To: Kathryn Espinoza, McKim & Creed
From: Brian Chambers, Senior Planner; 910.342.2782
CC: File;
Date: 1/28/2022
Re: Riverlights MX3 Road Improvements Revision 2 TRC Rev. 1

Project Name: RIVERLIGHTS MIXED-USE PHASE 3 ROAD IMPROVEMENTS

Project Name: Riverlights MX-3 Modification
Reviewer: Eric Seidel, PE
Department: Engineering – Plan Review Section

Riverlights Mixed-Use Phase 3 Standard Street Lighting Plan

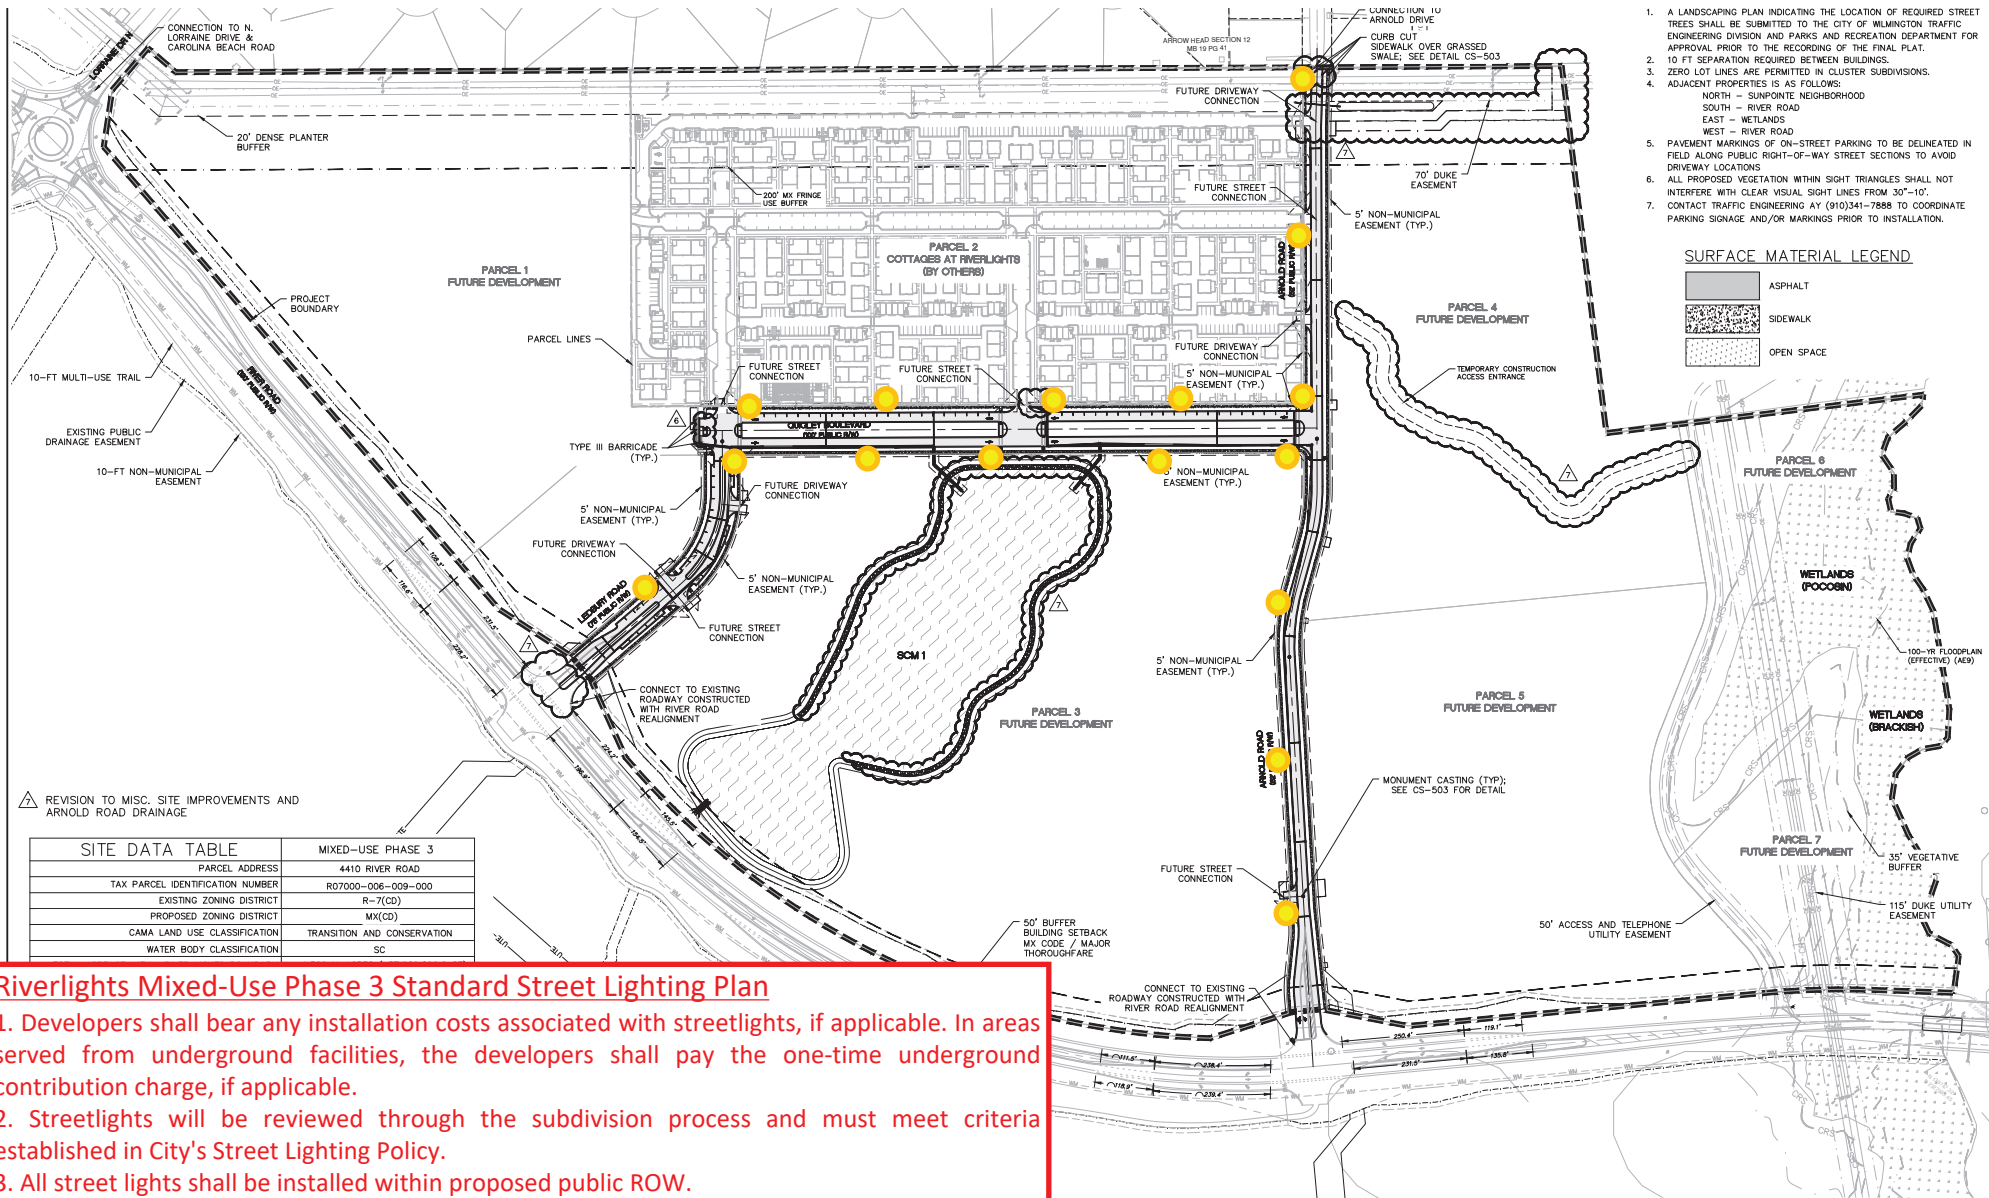
STREETLIGHTS:

1. A standard streetlighting layout for an updated plan is provided for the record purpose.
2. If non-standard post-top streetlights are desired, the spacing should be ½ of the standard streetlights spacings as outlined in City streetlighting policy.
3. Streets lights are required to be installed on all the proposed public ROWs in accordance with City streetlight policy prior to the acceptance by City for the maintenance.
